Jagg oil filter adapter gaskets

Background: Over the years there have been a few revisions to the 4600/4700 offset oil filter adapters that have necessitated changes to the gasket patterns.

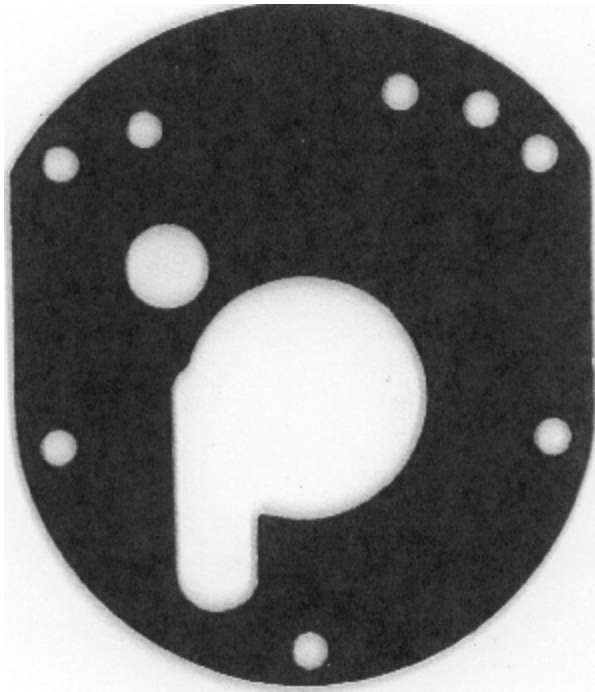
This gasket was produced for the original 4600 offset oil filter adapters from 1998-early 2000. First produced in Nitrile rubber it was recreated in AFM (Aluminum Foamette Material) in 2003 to replace the original nitrile gaskets that were found to squeeze out of position after time.

This gasket was produced for the first revision of the 4600 and the introduction of the 4700 offset oil filter adapters from early 2002-late 2003. First produced in Nitrile rubber it was recreated in AFM (Aluminum Foamette Material) in late 2003 to replace the original nitrile gaskets that were found to squeeze out of position after time.

The revised 4600 and new 4700 used #8-32 screws until changed to #10-24 screws in late 2002.

This gasket was produced for the 2nd revision of the 4600, and the 1st revision of the 4700 in late 2003-early 2009. This gasket was always produced in AFM (Aluminum Foamette Material). Very early versions of this gasket were produced with symmetrical top holes. It was determined that the symmetrical top holes could allow the gasket to be installed backward. Therefore, the 4600/4700 and this gasket were revised to offset the top holes to ensure gasket could only be installed properly.

This gasket was only produced in AFM for the 3rd revision of the 4600, 2nd revision of the 4700 in early 2009-present. These revisions placed all screws on the same side of the offset oil filter adapters and eliminated unnecessary gasket passages in favor of favorable stamping finish.
